Starter Tech Note

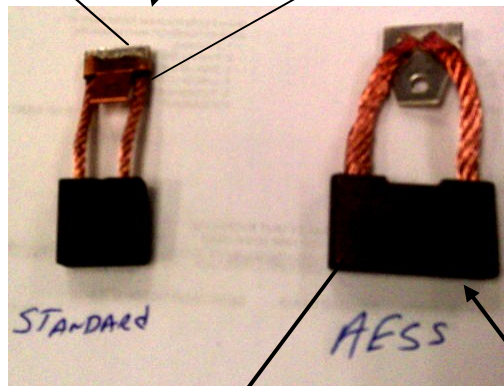
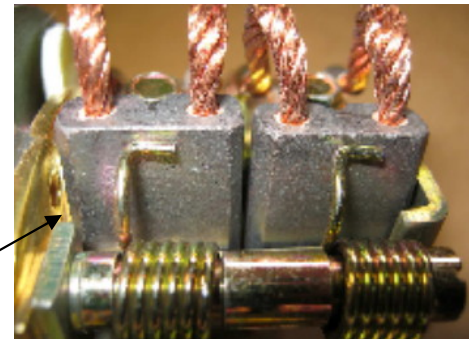
Issue – AEES (automatic start stop system) decrease life on starter due to the drastic increase in duty cycles. Starters are lasting under 1 year due to the AEES application.

Standard Brushholder Uses Qty 2 Brushes per Box

E1967354AEES Brushholder uses Qty 1 High Amp Brush

Solution – PowerRail has developed the AEES starter on UX basis P/N E8384834AEES-UX.

Features – New Armature, New Solenoid, modified Brushholder and High Amperage Brush.
